Van Stone Mine cleanup

Questions & answers: Cleanup Action Plan public meeting

The Washington Department of Ecology held a public meeting June 8, 2023, at the Onion Creek School to explain the proposed Cleanup Action Plan ([view the presentation](#)¹), answer questions, and accept written comments.

Figure 1. Soil and sediment sampling locations³

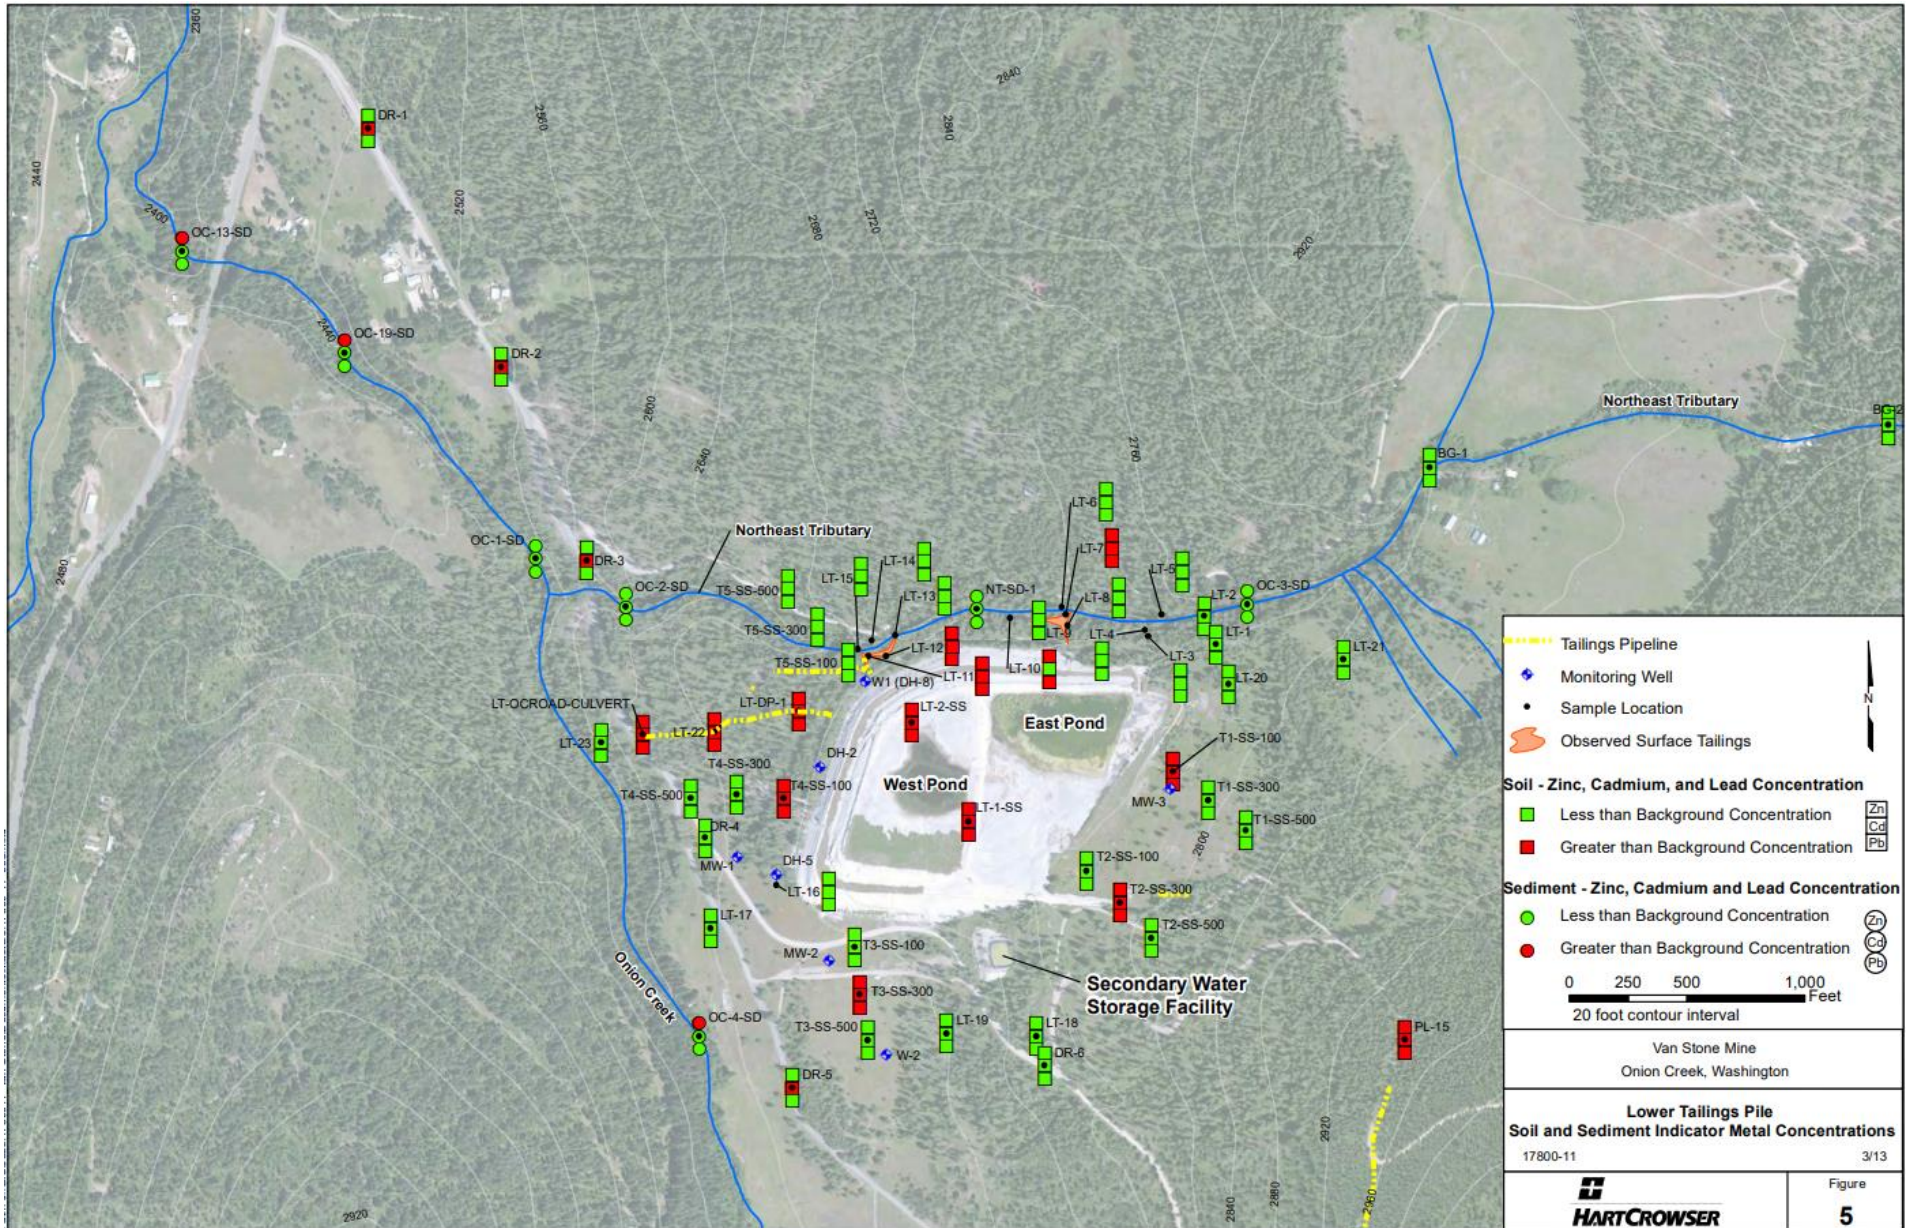
Q7: Where was soil tested? Was the school tested?

A7: Soil near the school was tested. Some samples had elevated metals, but the exposure pathway was removed when the road was paved. Surface water and sediment samples from near the school met human health criteria. The school's drinking water well results also met drinking water standards. We can test the school property soil and drinking water throughout cleanup construction.

See figures 1 and 2 (pages 3–4) for all the soil and surface water sampling locations and results.

Figure 2. Surface water sampling locations⁴

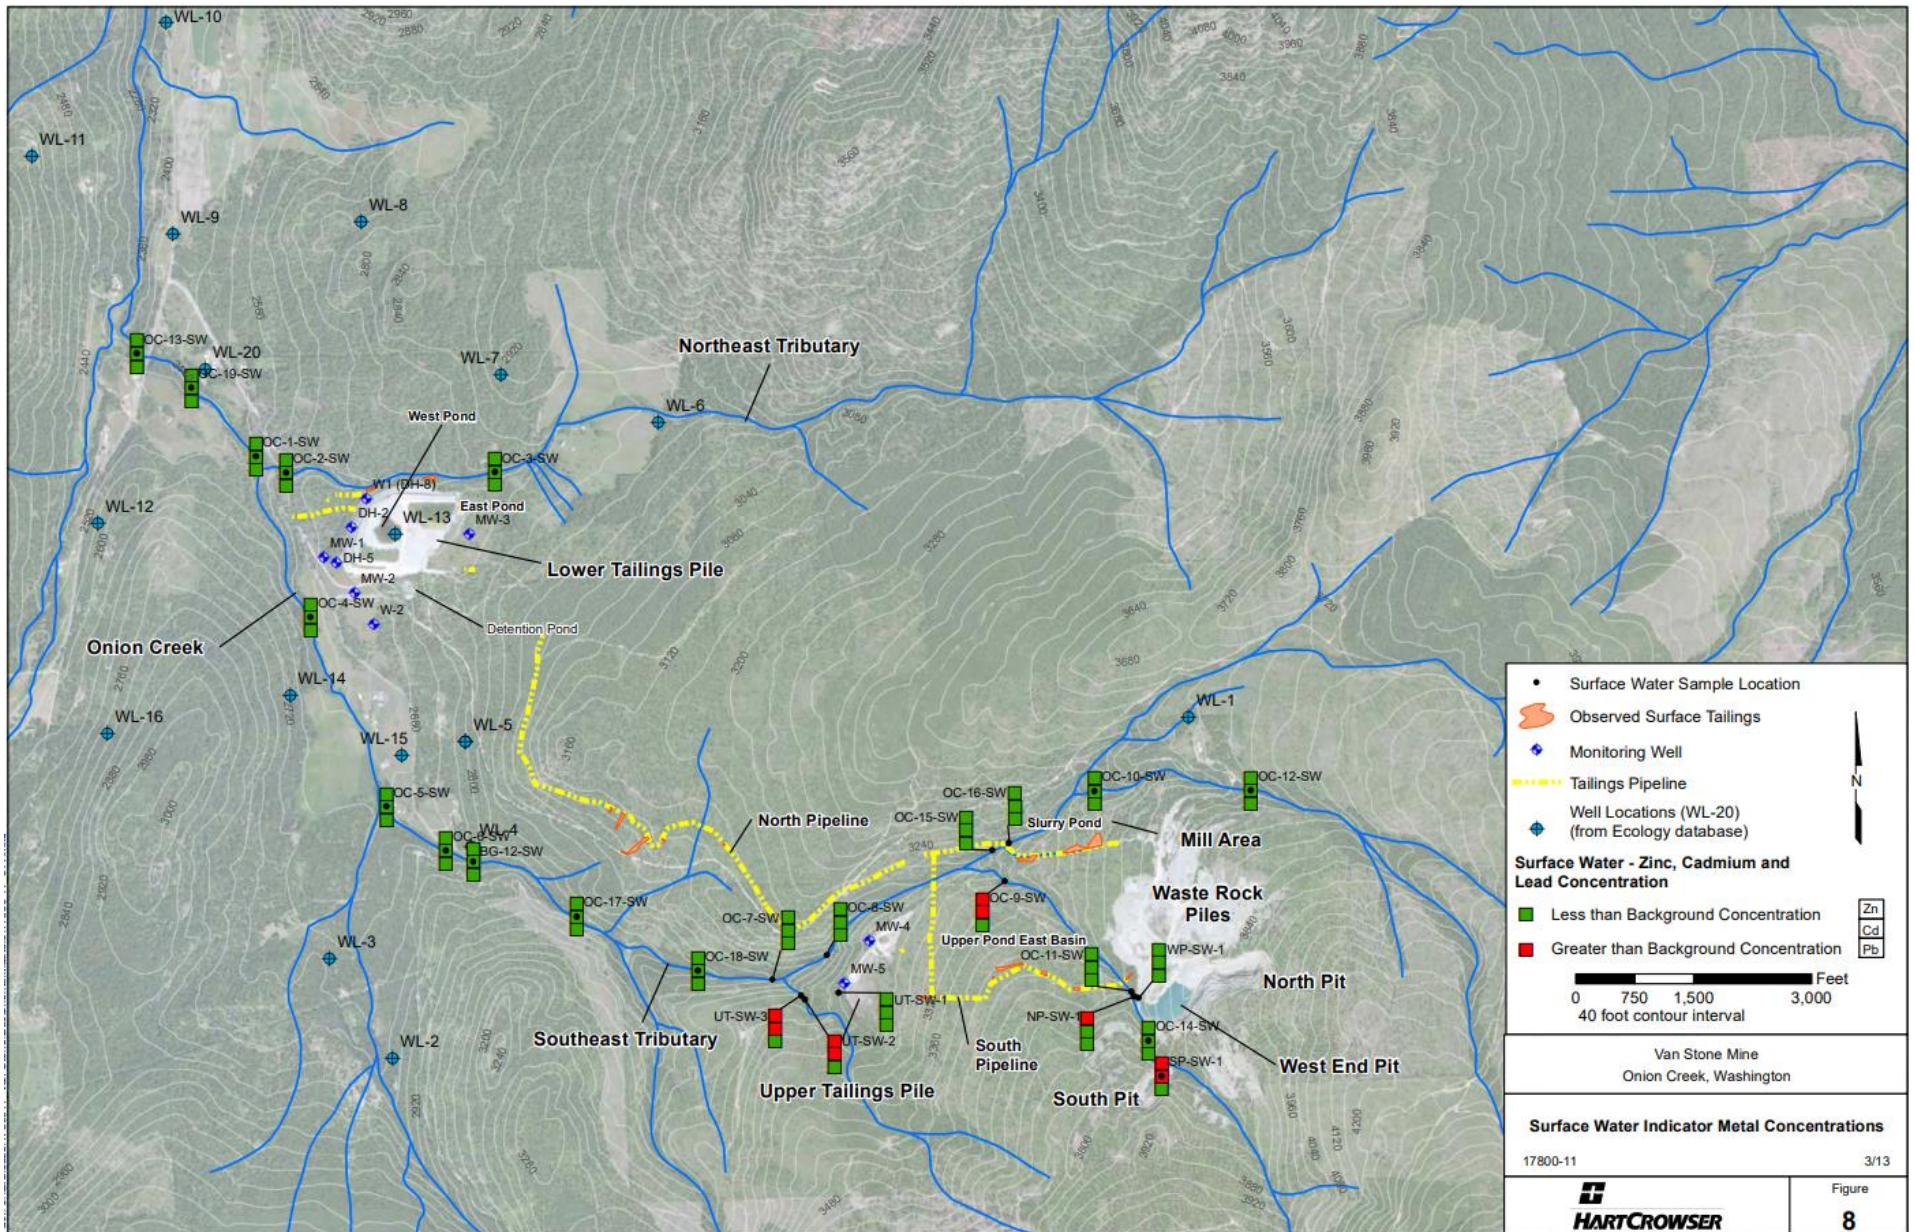
Q13: Did you sample the nearby creeks?

A13: Yes, we sampled the water and sediment (soil, sand, rocks in and next to the creek bed).

See Figure 2 for locations.
